## **NOTIFICATION 15-09-15**

Subject: Mechanical Push Button Spar Pin Switch Upgrade

Affected Models: RV-12

**FIGURE 1: MARKING A CENTERLINE**

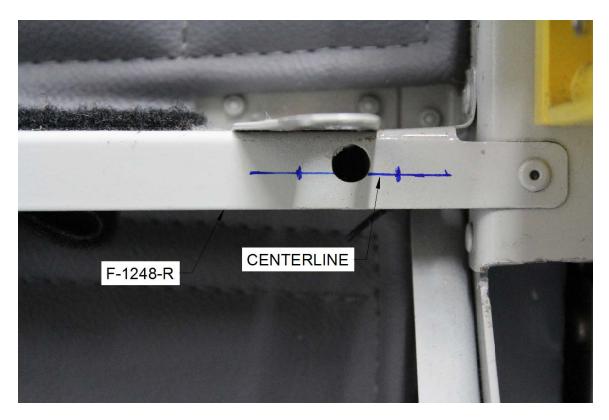
Step 1: Locate the hole in the vertical flange of the F-1248-R Arm Rest. Using the hole as a starting point, draw a centerline on the flange extending an inch forward and an inch aft of the hole. Make marks on the centerline 0.375 inches aft and 0.375 inches forward of the center of the hole.

FIGURE 2: ALIGNING THE SWITCH PLATE

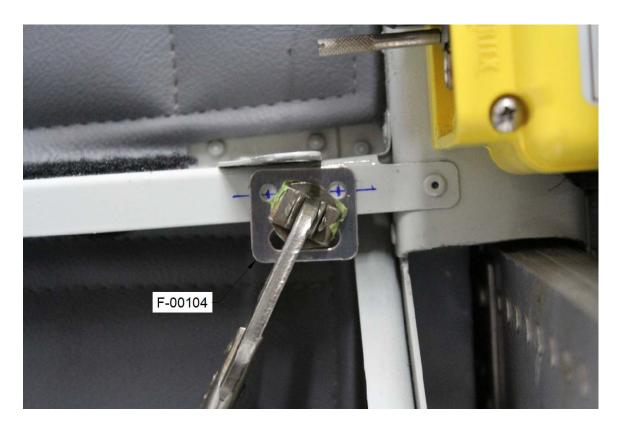
Step 2: Clamp an F-00104 Spar Pin Switch Plate to the inboard face of the flange and center the part about the marks made on the centerline in the previous step.

Match drill #19 the flange of the arm rest using the spar pin switch plate as a guide.
